ANADROMOUS WATERS CATALOG/ATLAS
CORRECTION FORM

Describe Change(s): Changes involve corrections to annotation where fish species codes are missing or AWC# is in error

Nomination Number: CB-368

From: Barnhill, Carol A (DFG)
Sent: Friday, February 13, 2009 6:19 PM
To: Johnson, J D (DFG)
Subject: AWC species errors

#17
106-30-10670-2004-3028
COp
COp
COsr,Ps
106-30-10670-2004-3028-4006
COsr,Ps
106-30-10670-2004-3022
COp
COp

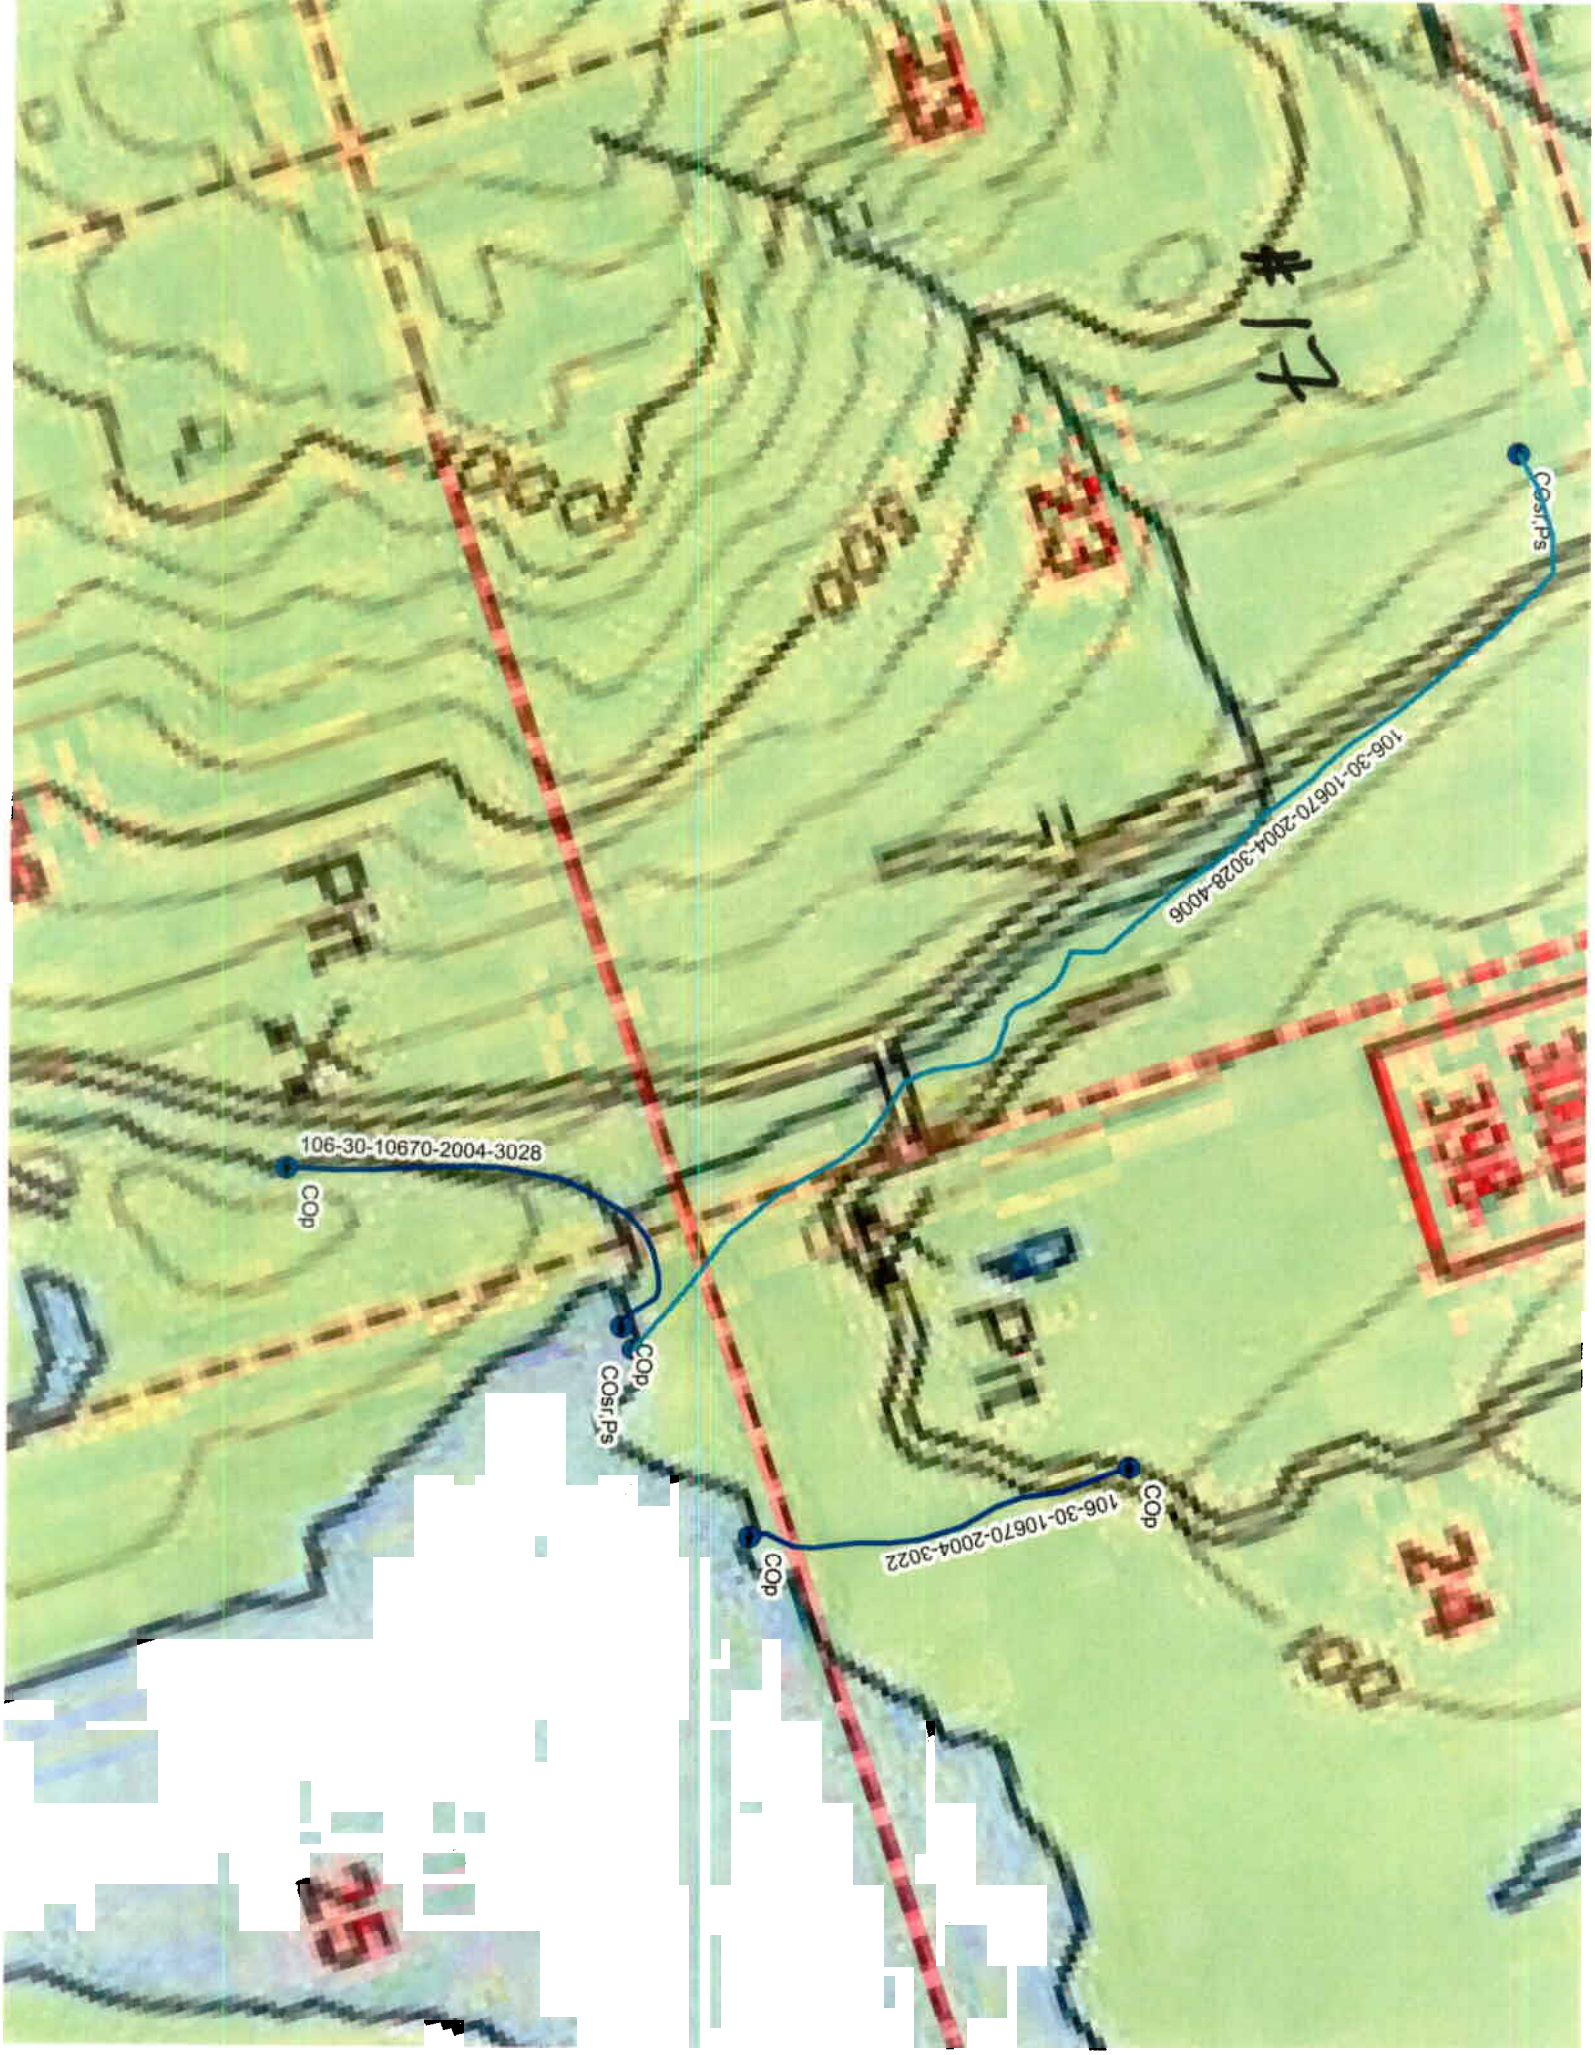
16	102-70-10580-2017-3010	Craig C-2	No SH in -2017 or -0010
17	106-30-10670-2004-3028-4006	Craig D-3	No P in -3028
18	111-50-10750-2033-3007	Juneau B-2 SW	No CT,DV in -2033
	111-50-10750-2033-3014	Juneau B-2 SW	No CT,DV in -2033
	111-50-10750-2033-3018	Juneau B-2 SW	No CT,DV in -2033
19	113-81-10110-2012-3002	Sitka C-6 & C-7	~~No CH,P in -2012~~ (should this be a 3rd order?)
20	115-32-10250-2008-3004	Skagway B-2	No K in -2008
21	115-32-10250-2077-3136-4002	Skagway B-4 NE	No CT in -3136
22	182-70-10100-2020-3021	Yakutat C-4 SW & C5SE	No SH,DV in -2020
	~~182-70-10100-2022-3011~~	~~Yakutat C-4 SW~~	~~No SH in -2022~~
23	182-70-10100-2022-3017	Yakutat C-4 SW	No SH in -2022

AWC#	Atlas map	Error on map	Corrective action
192-30-10100-2040	Bering Glacier A-5	No K in -2040	Add Chinook salmon to water body
192-41-10100-2022-3007	Bering Glacier A-5	No CO in -3007	Add coho salmon to water body
102-70-10580-2017	Craig C-2	No SH in -2017	Add Steelhead Trout to water body
106-30-10670-2004-3028	Craig D-3	No P in -3028	Add pink salmon to water body
111-50-10750-2033	Juneau B-2	No CT,DV in -2033	Add Cutthroat Trout & Dolly Varden to water body
111-50-10750-2033	Juneau B-2 SW	No CT,DV in -2033	Add Cutthroat Trout & Dolly Varden to water body
113-81-10110-2010	Sitka C-6	Renumbered to allow additional AWC#	Renumber as 113-81-10110-2008
113-81-10110-2012-3002	Sitka C-6	Should be 2nd level water body	Renumber as 113-81-10110-2010
115-32-10250-2008	Skagway B-2	No K in -2008	Add Chinook salmon to water body
115-32-10250-2077-3136	Skagway B-4	No CT in -3136	Add Cutthroat Trout to water body

COp
182-70-12000-2013
Pp
COr
182-70-12000-2026
COr
26
27
27
34
34
Cabin
COpr,DVp
DVp
182-70-12000-2020
COr,SHr
COp
COs
COr,SHr
COr,SHr
182-70-12000
182-70-12000-2020-3004
182-70-12000-2018
COr,SHr
COp
182-60-10100-2015
182-60-10100-2015-3130
COr

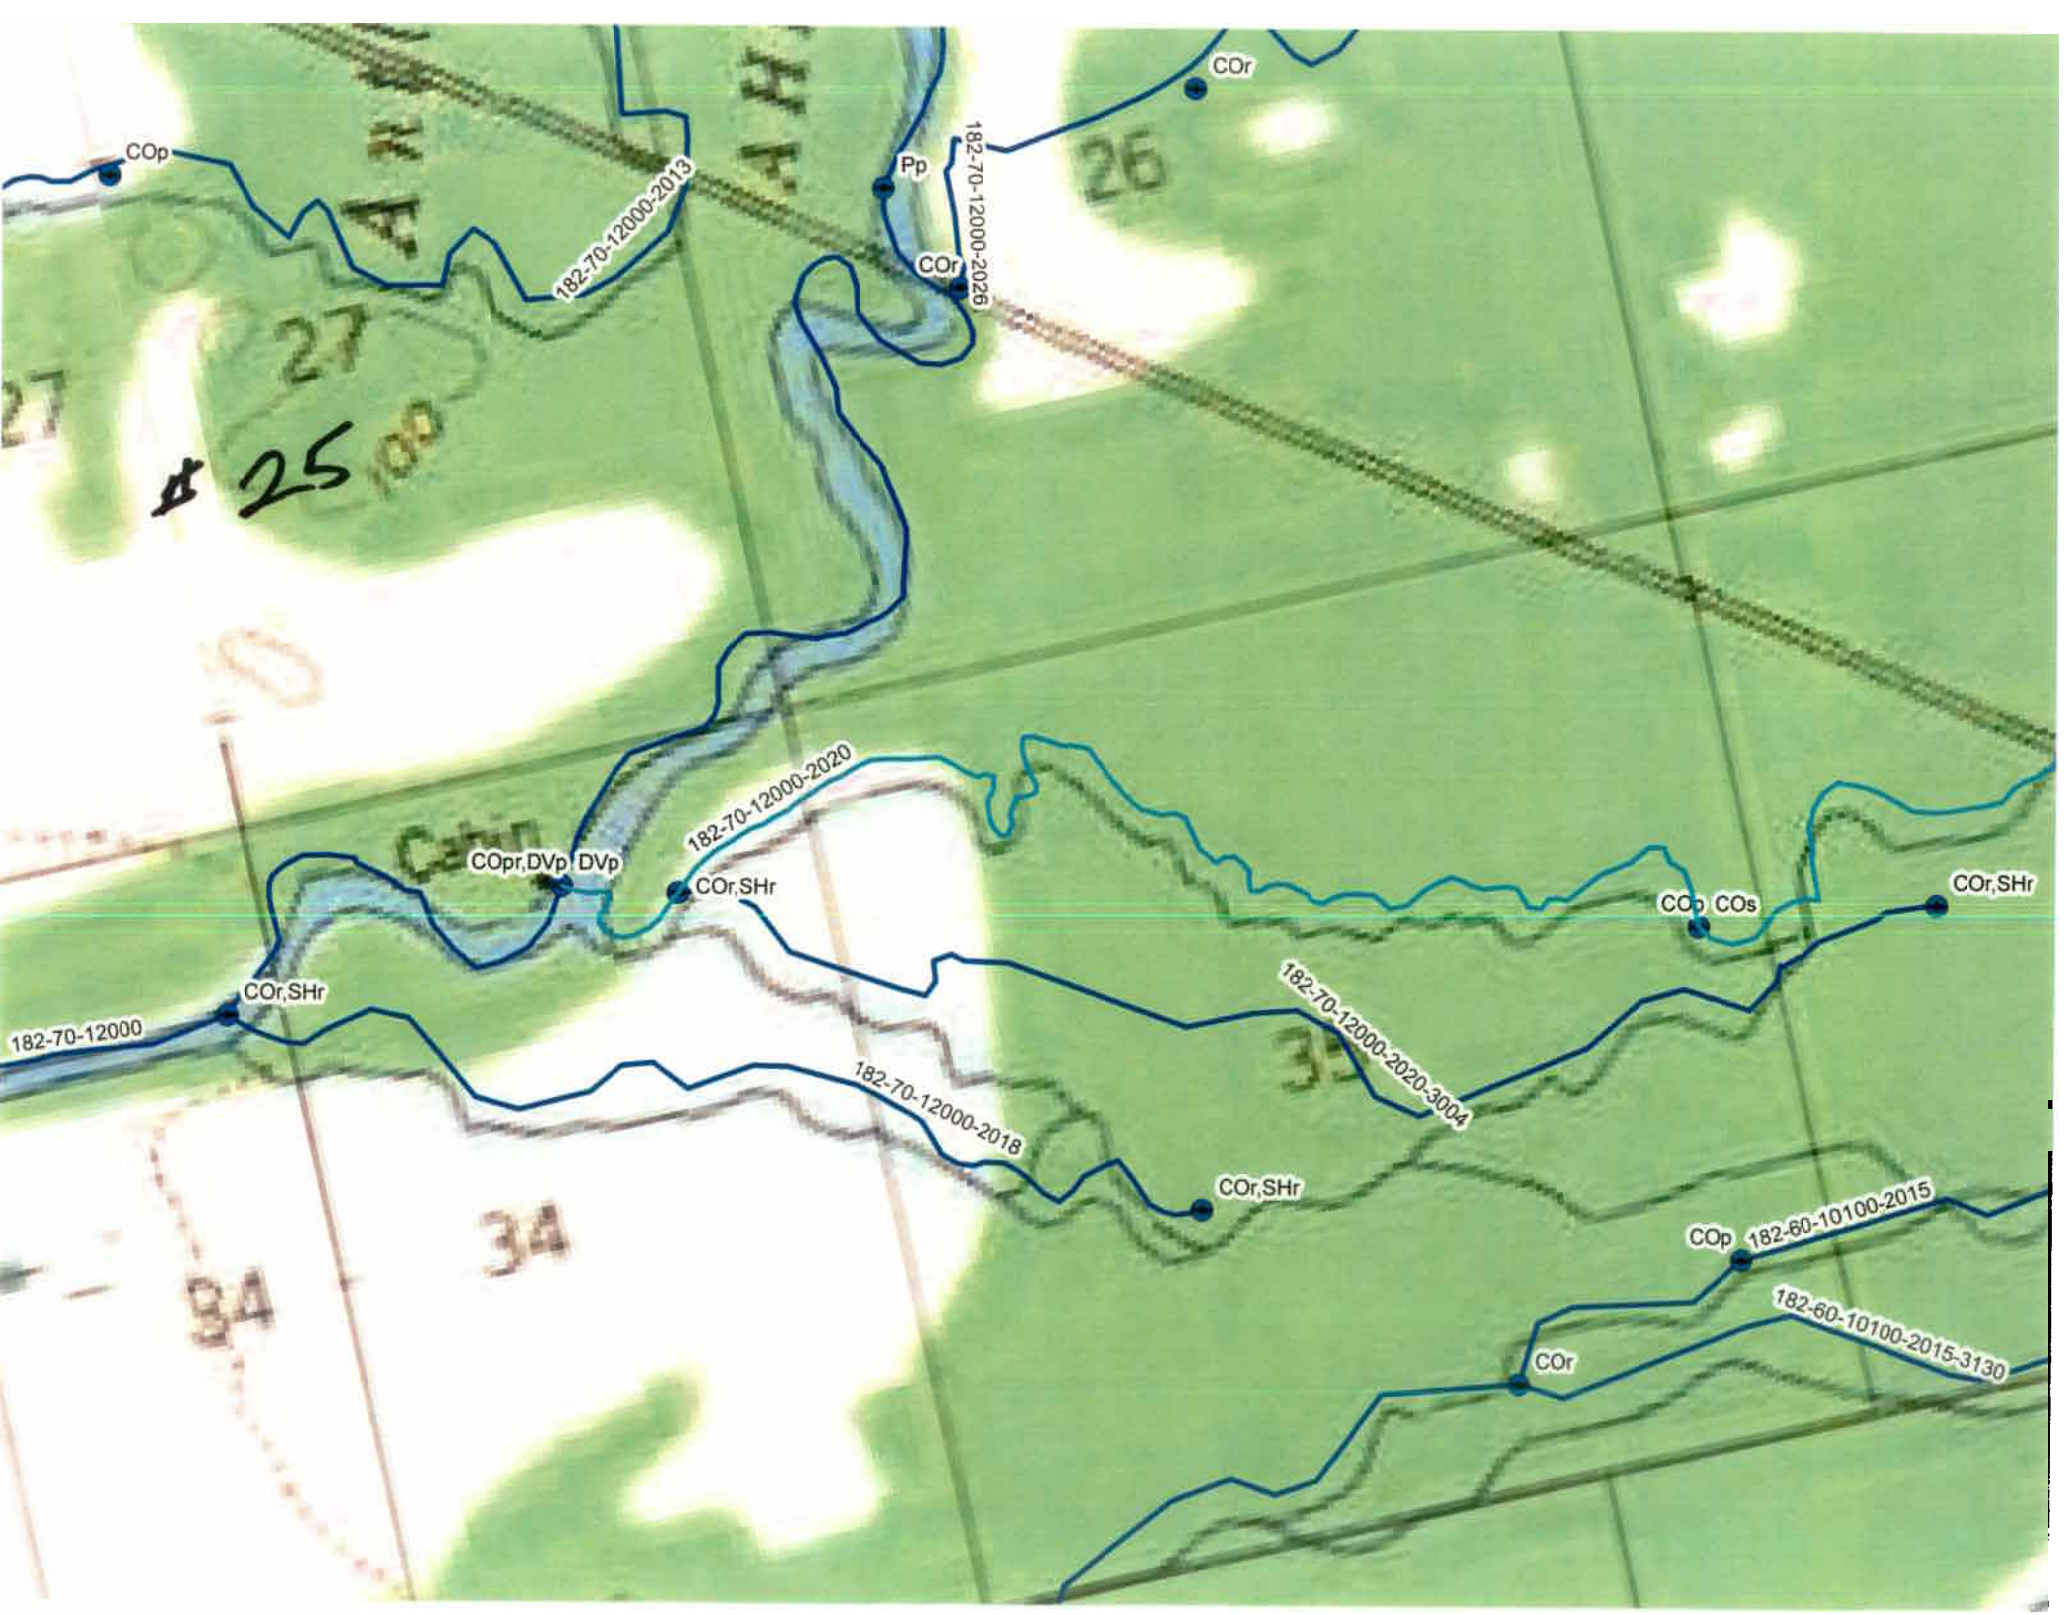
182-70-12000-2006-3101	Yakutat B-4	No K,SH in -2006
182-70-12000-2006-3130	Yakutat B-4	No K,SH in -2006
182-70-12000-2020-3004	Yakutat B-3	No SH in -2020
192-30-10100-2040-3106	Bering Glacier A-5	No K in -2040
192-41-10100-2022-3007-4010	Bering Glacier A-5	No CO in -3007

115-32-10250-2077-3136	Skagway B-4 NE	No CT in -3136	Add Cutthroat Trout to water body
182-70-12000-2020	Yakutat B-3	No SH in -2020	Add Steelhead Trout to water body
182-70-12000-2006	Yakutat B-4	No K,SH in -2006	Add Chinook salmon & Steelhead Trout to water body
182-70-10100-2020	Yakutat C-4	No SH,DV in -2020	Add Steelhead Trout & Dolly Varden to water body
182-70-10100-2022	Yakutat C-4	No SH in -2022	Add Steelhead Trout to water body
182-70-10100-2020	Yakutat C-4 SW	No SH,DV in -2020	Add Steelhead Trout & Dolly Varden to water body
182-70-10100-2022	Yakutat C-4 SW	No SH in -2022	Add Steelhead Trout to water body
